COASTAL RESOURCES MANAGEMENT COUNCIL

TUESDAY, MAY 14, 2019

CRMC DECISION WORKSHEET
2018-04-078
John F. Crandall

1.5 acre shellfish farm

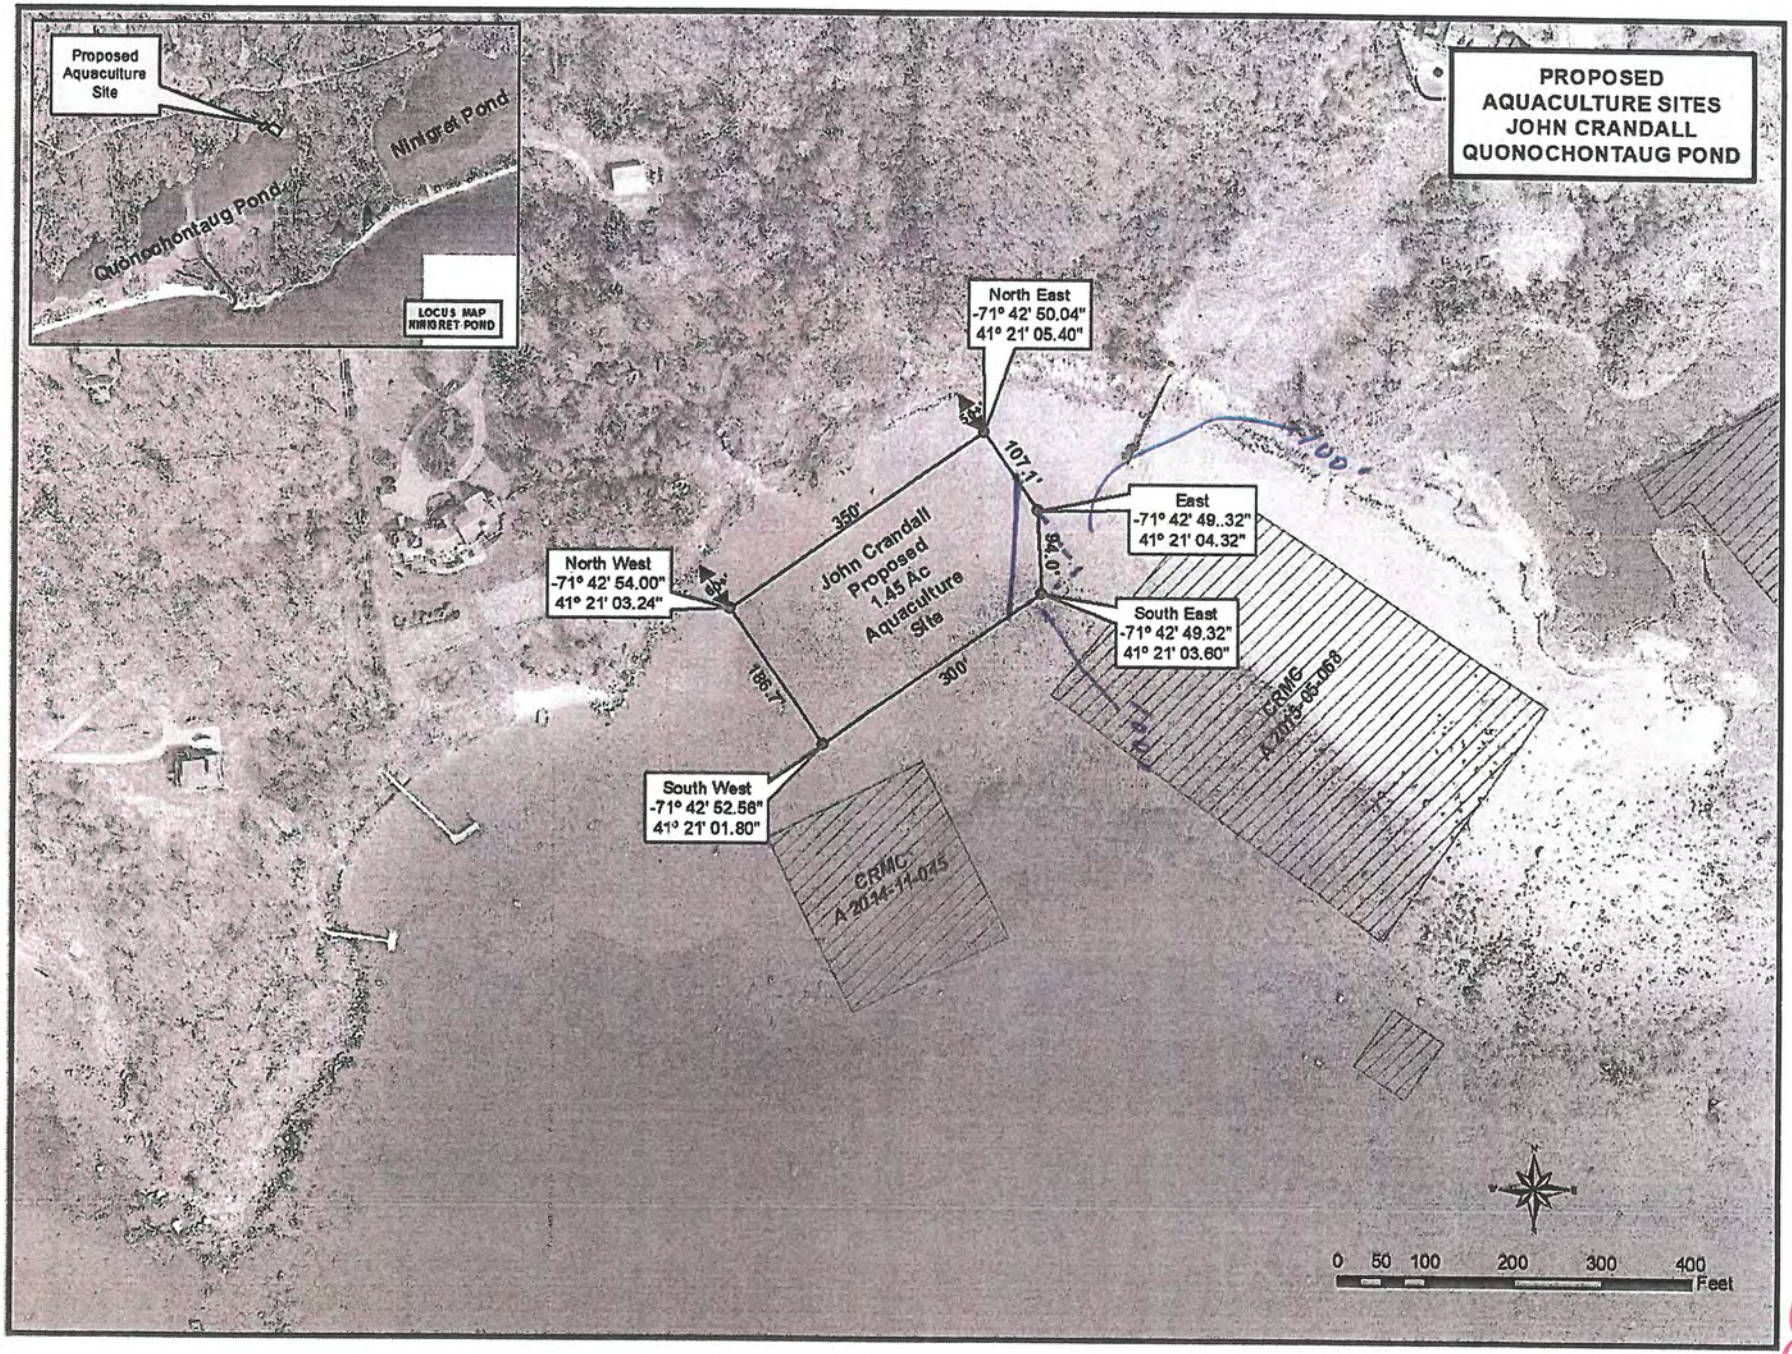
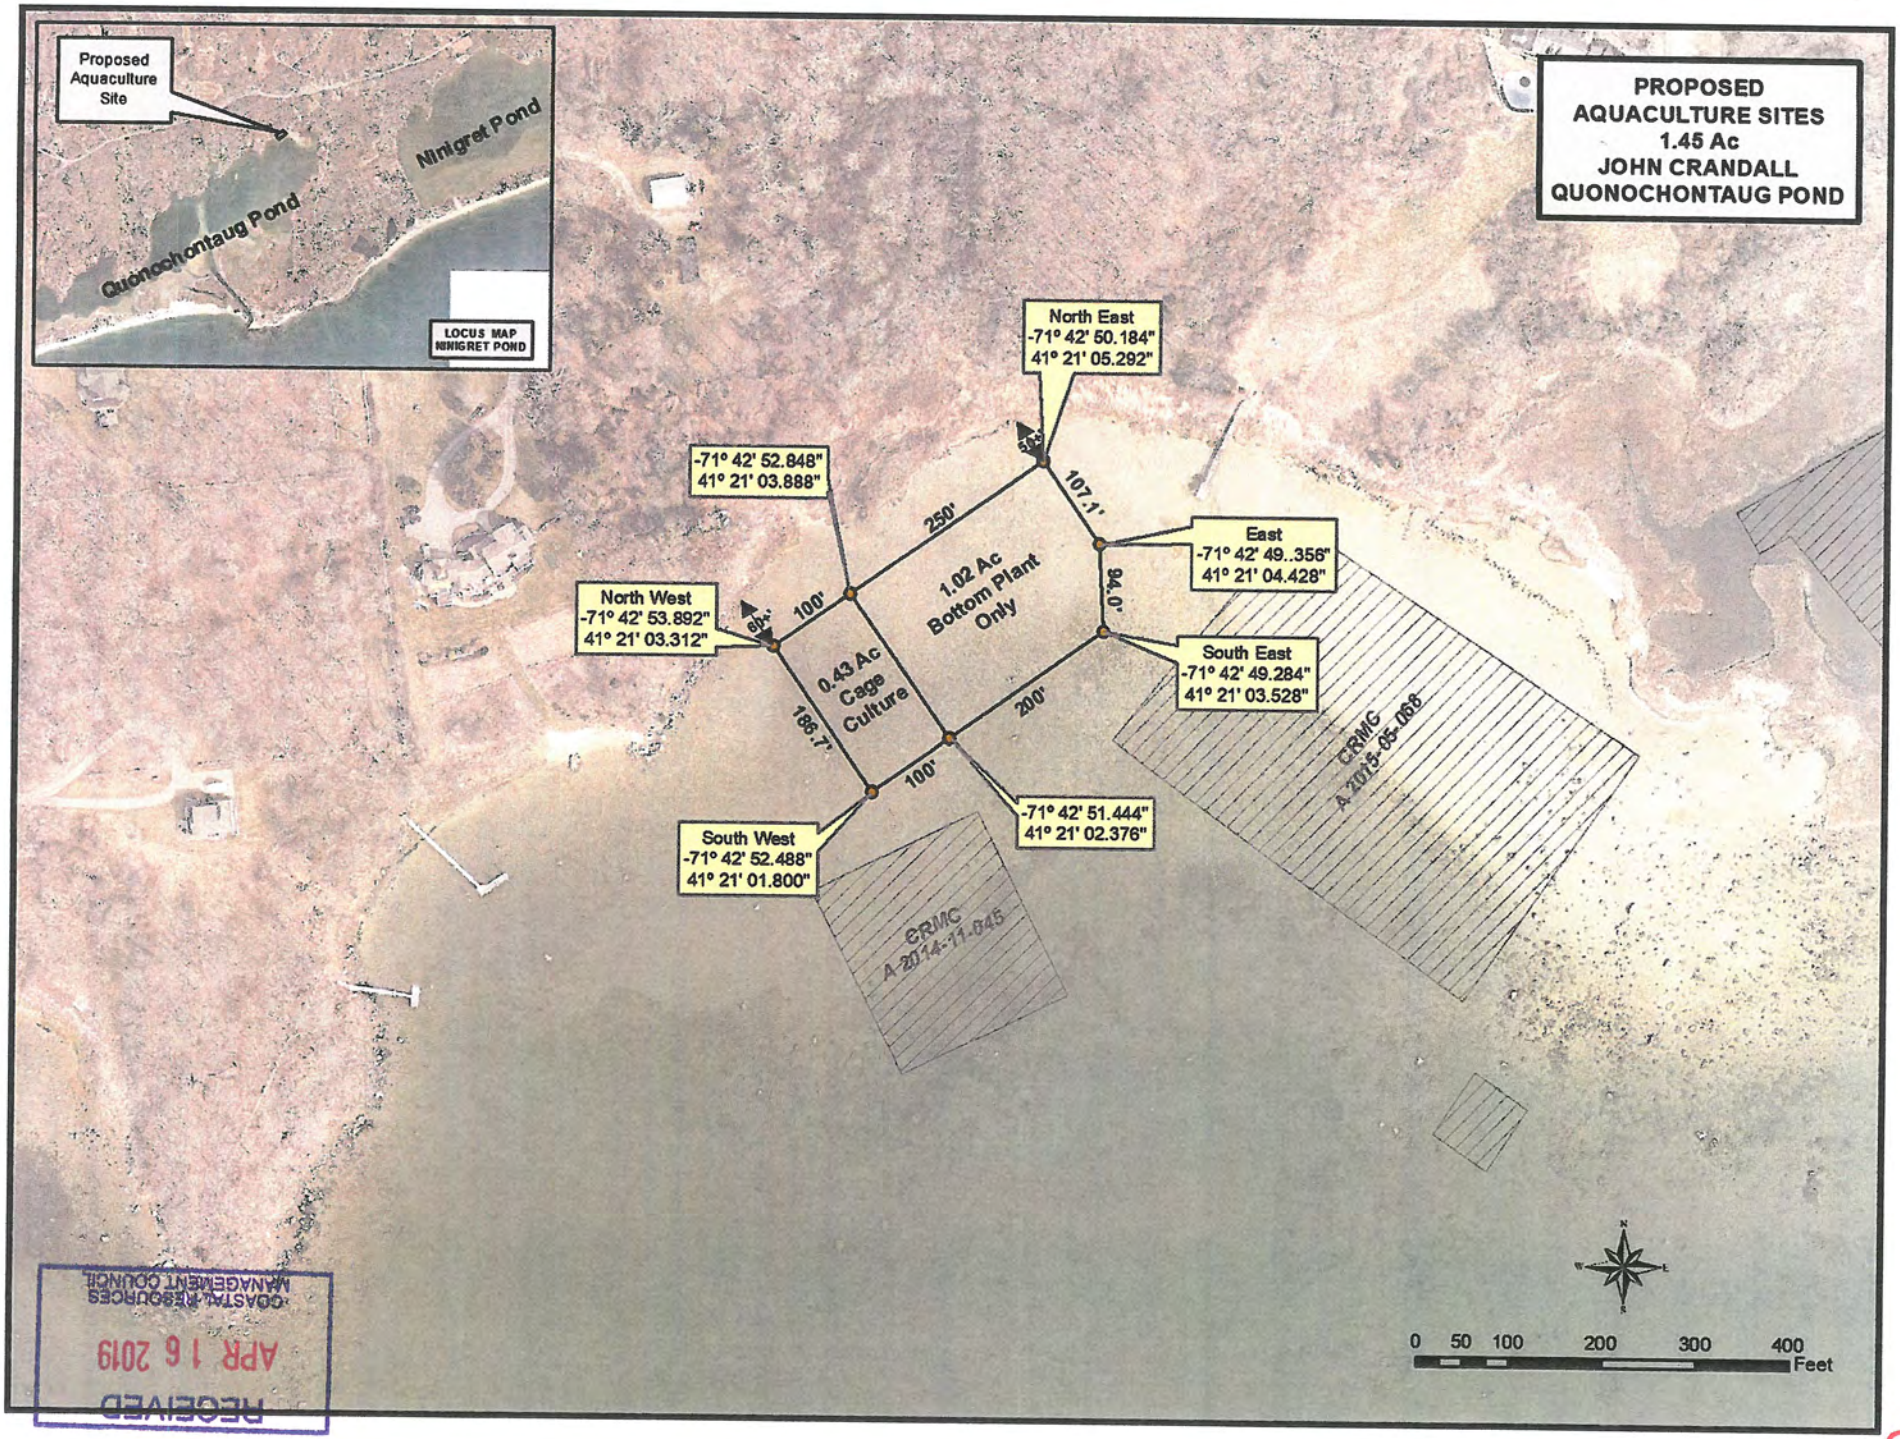
Gentlemen, based on this sketch, this represents 25% (1250 square ft) of the amount (5000 square ft) that we and the Council agreed upon at the last meeting. We propose lopping off 100' at each corner, which will provide for a reduction of 5,000 square feet, an amount sufficient to provide adequate access to Mr. Whitney's dock. Kindly provide a new drawing with those coordinates.

Please share the attached map of the proposed Crandall lease site with Mr. Whitney. This change is what I had mentioned during the discussion with the Council on March 12. The northeast corner was bisected by a distance of fifty feet with the subsequent line drawn down each of the northern and eastern sides. Removing this corner should provide Mr. Whitney sufficient space to navigate and meets the parameters of the approved motion. Please review and comment. This change is acceptable to Mr. Crandall. Thank you.

Attached are the dueling maps we have - one showing 50 feet taken off the corner and one showing 100 feet taken.

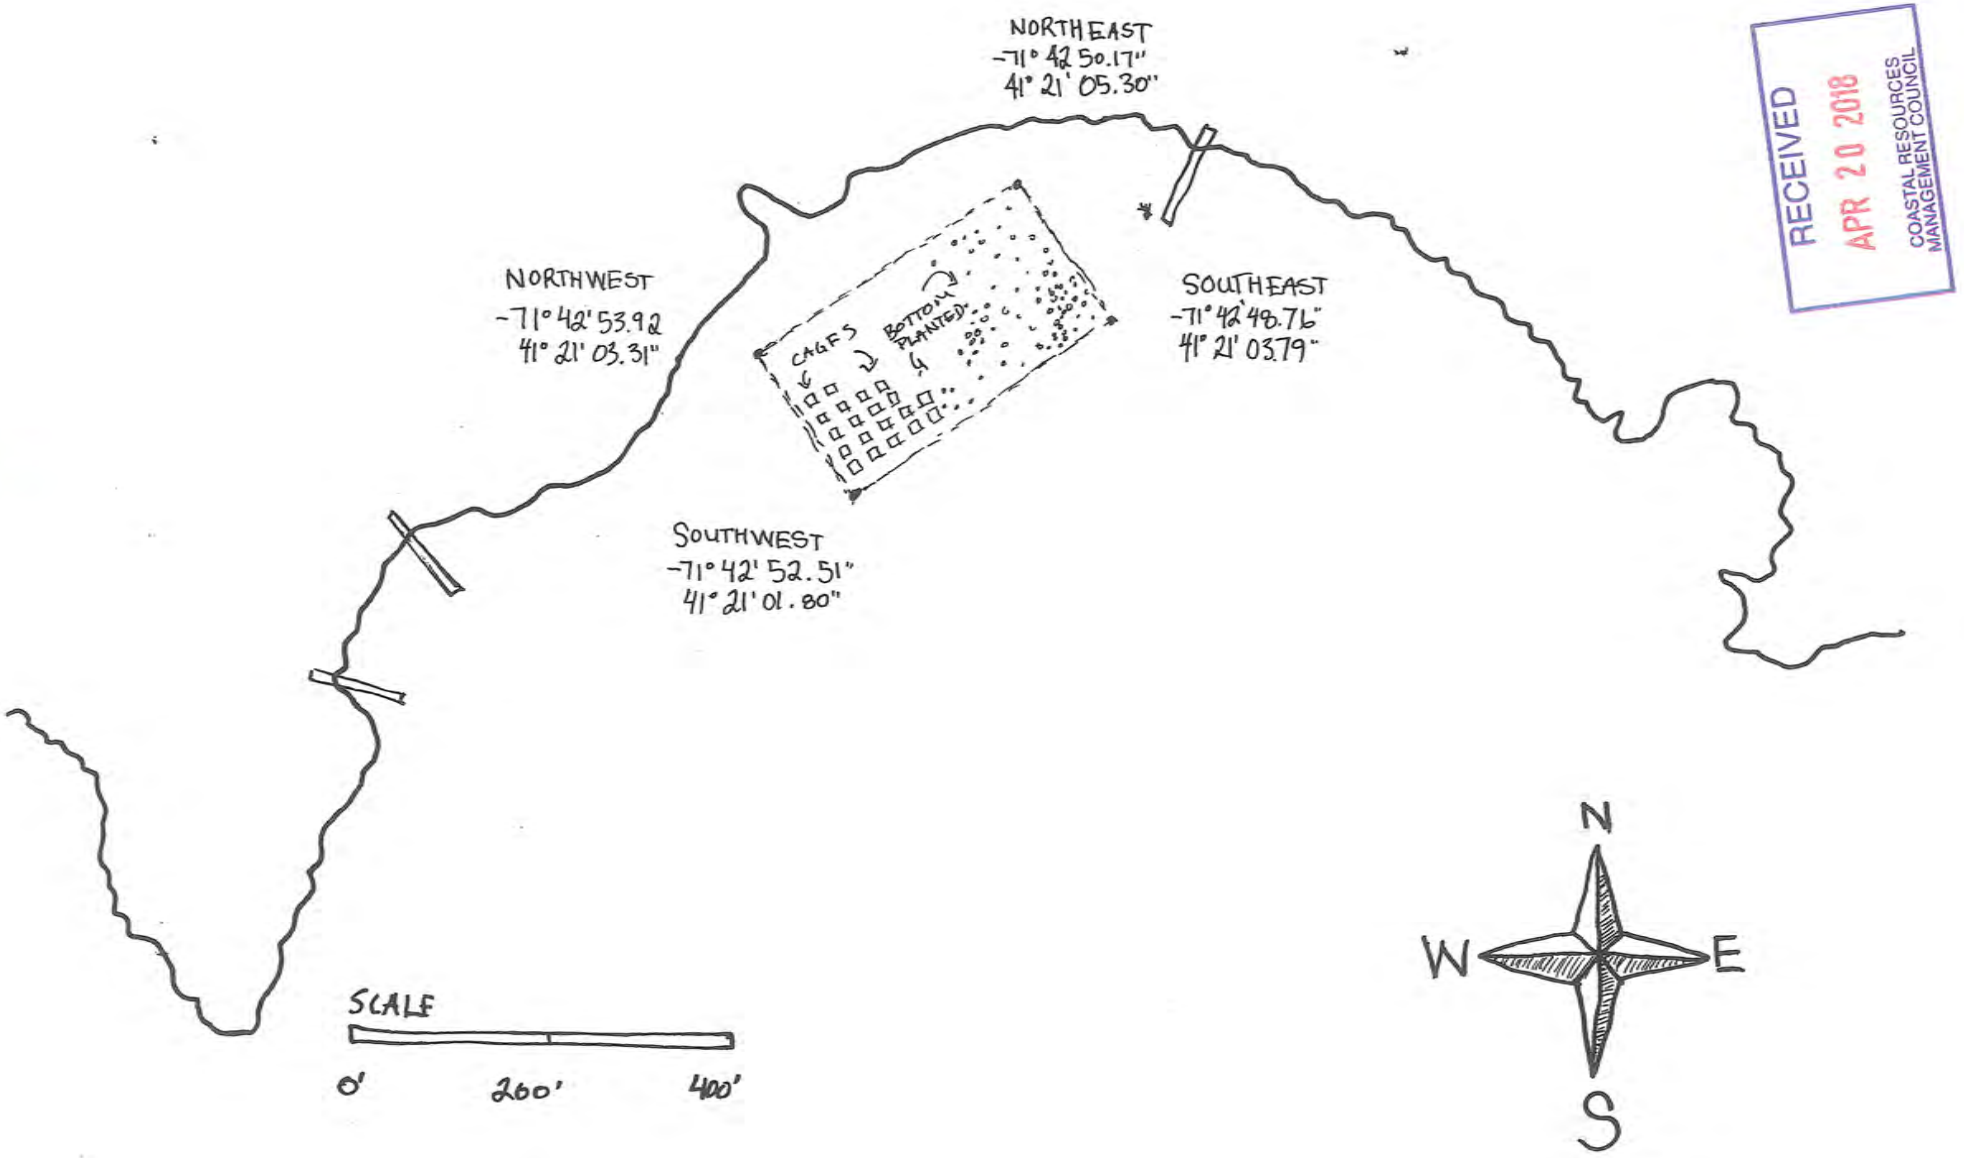
MR. BEUTEL: This is an application for 1.5 acres, an acre and a half of a combination of cage aquaculture that's on the southern part of the proposed lease area. So that's the map on Page 5. The northern and eastern parts are bottom plant. To be clear, bottom plant, and this is bottom plant for oysters, quahogs and steamers. Quahogs and steamers live in the sediment; so they wouldn't even be on the sediment. They would be lower than the sediment. The oysters in the bottom plant area would be on the sediment.

MR. BEUTEL: So the map on Page 5 shows the adjacent aquaculture leases and may give a better perspective. I want to make clear that the aquaculture site that is to the east of the proposed area, the three-quarters of that that are adjacent to Crandall's proposal, are all bottom plant; so it's a wide area of bottom planted oysters is the bottom.

MR. BEUTEL: I might recommend that rather than 50 feet end to end, bisecting the southeast corner by 50 feet and making this five sided would certainly provide plenty of ingress and egress to Mr. Whitney's dock.

MR. ALLARD: The drawing on Page 5. So my client wouldn't have an objection to modifying his area to just lopping off that corner.

Figure 1: Sea Level Rise based on CRMC Stormtools.

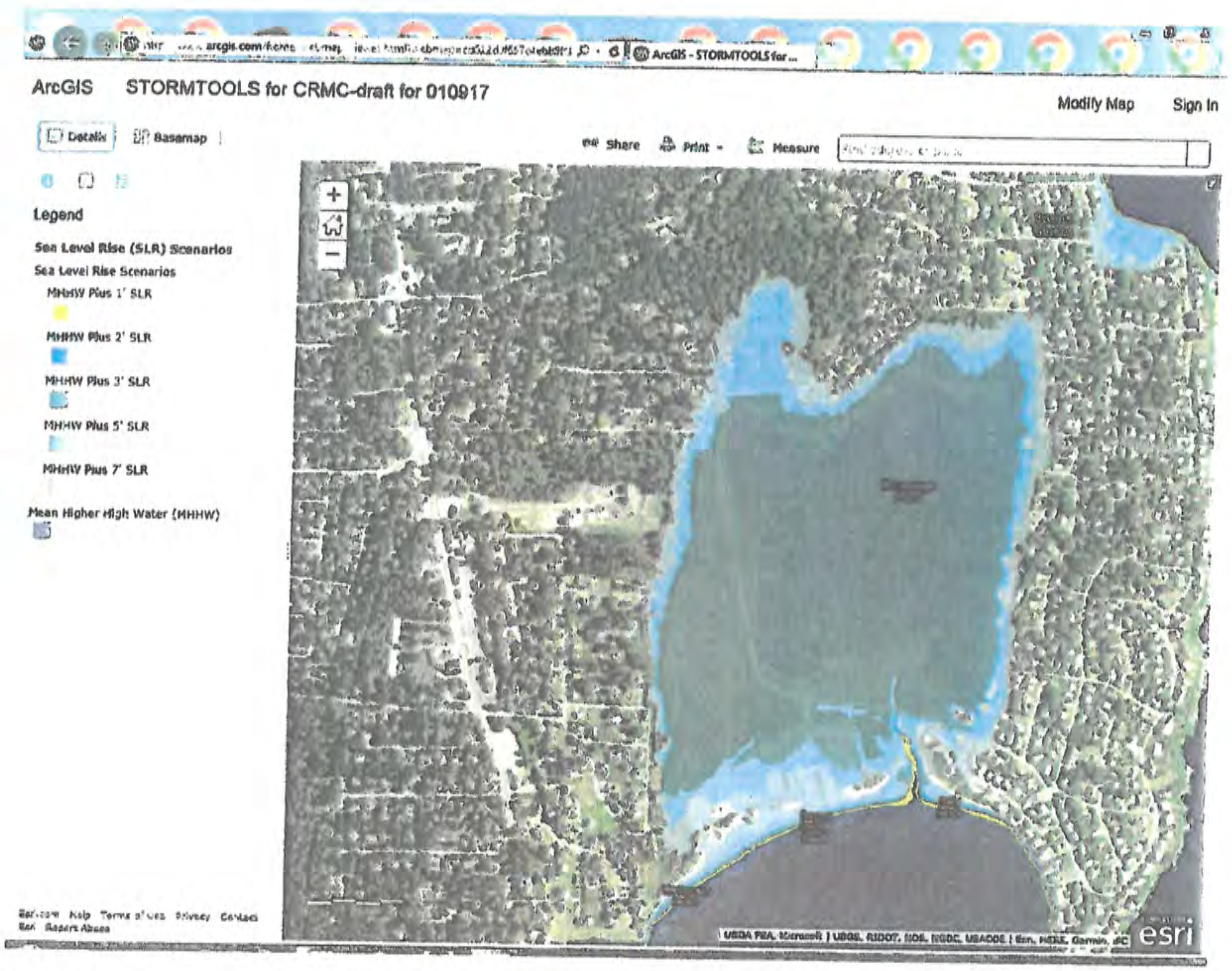
5. **Sea Level Rise and Flood Zone Considerations:** As shown in Figure 1 below, Bonnet Point Road (the causeway) will be flooded during high tides with 3 feet of Sea Level Rise (SLR). Accordingly, the causeway will no longer be accessible for vehicle (or foot) traffic. Based on currently expected rates of SLR, sea level is expected to rise 3 feet by 2065. This should be considered by the project proponents and in the project design should the project move forward. It is further important to consider that the boardwalk (as shown on the preliminary plans) will not provide access to and from "dry land" with 3 feet of SLR. Rather, both ends of the boardwalk will be flooded. Furthermore, any sewer line to be attached to the boardwalk should be designed for inundation (and coastal storm impacts).

Figure 2: RI Emergency Management Agency Flood Plain Mapping Tool.

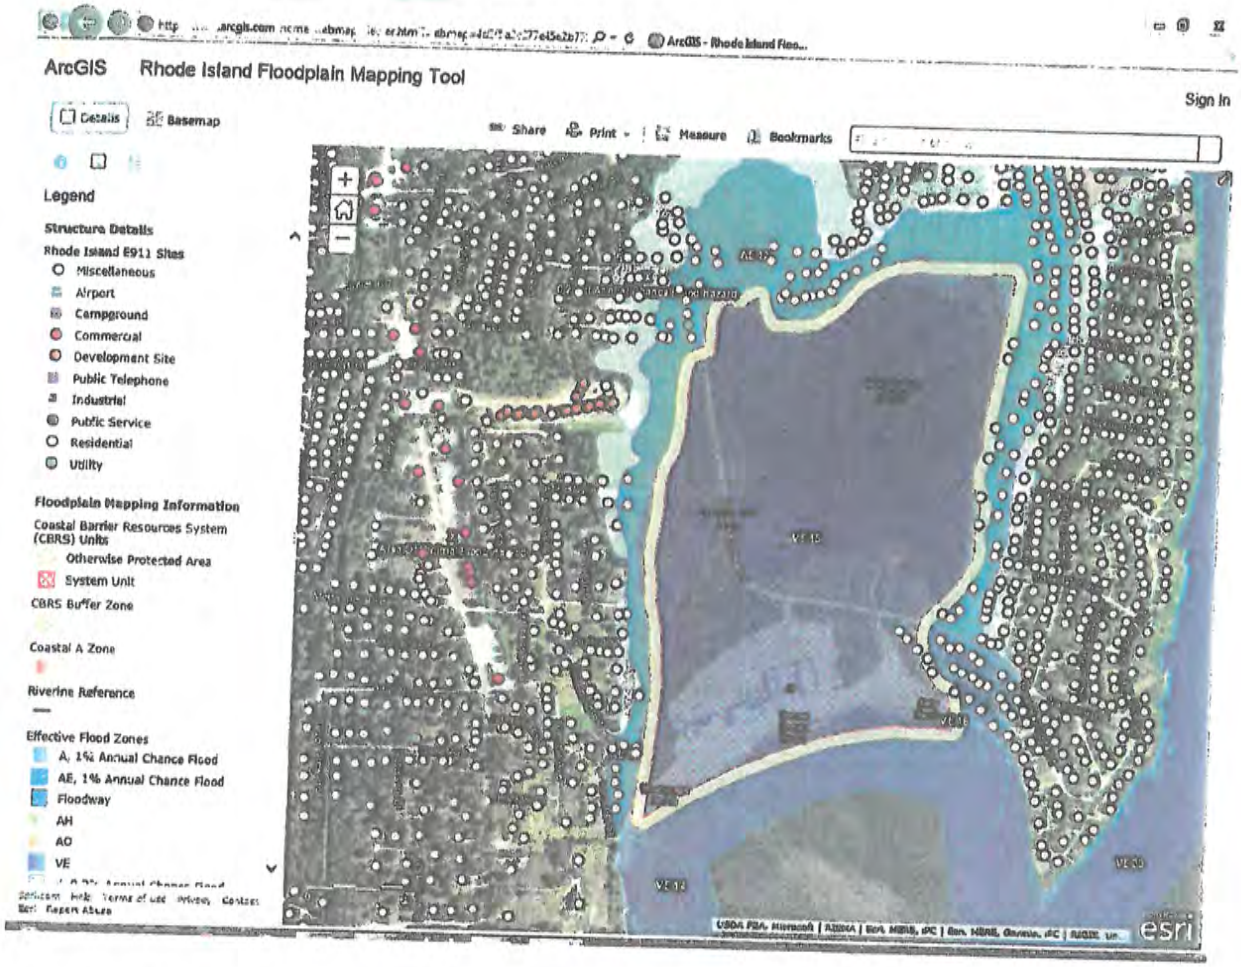
Pursuant to Figure 2 below, the project area is currently located within a VE 15 flood zone (absent consideration of SLR). Accordingly, the boardwalk (and any attached sewer line) should be designed to survive a 100 year storm with "V" zone (wave) conditions.

TYPICAL TRENCH DETAIL FOR GRAVITY SEWER PIPE

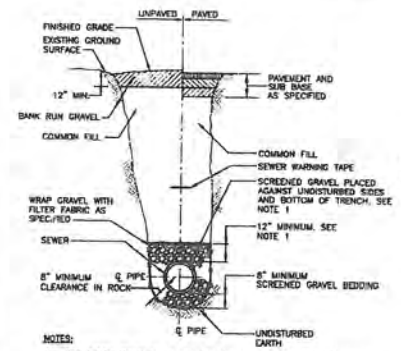
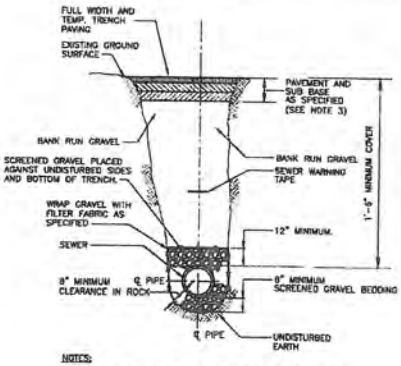
a. Plan Sheet CSD-1, "Typical Trench Detail for Gravity Sewer" and "Typical Trench Detail for Sewer Force Main". Common Fill is not acceptable for backfill for the anticipated soils to be encountered in the project area, as acceptable compaction cannot be achieved. Unless it can be demonstrated that 95% of the Modified Proctor Maximum dry density of the Common Fill is achievable, the full depth of the entire trench shall be backfilled with properly compacted processed gravel. The Town requires the applicant to provide compaction test results (per ASTM D 1556, ASTM D 2167, ASTM D 2922, and ASTM D 2937, as applicable) of the completed trench indicating that acceptable compaction has been achieved. A minimum of one test per 150 feet trench length is required. Existing excavated material not used for trench backfilling shall be removed from the project area and properly disposed. Provide revised plans addressing the above.

b. Plan Sheet CSD-1, "Typical Trench Detail for Gravity Sewer" and "Typical Trench Detail for Sewer Force Main". The detail label "Match existing Pavement and Subbase" is not acceptable. The pavement thickness for the full with road repaving shall be 2" asphalt base course and 2" asphalt surface course. The temporary patch shall be 1 ½ inch thickness asphalt base course. Temporary patching shall be applied daily to all completed trenches that are not steel-plated. Provide revised plans addressing the above.
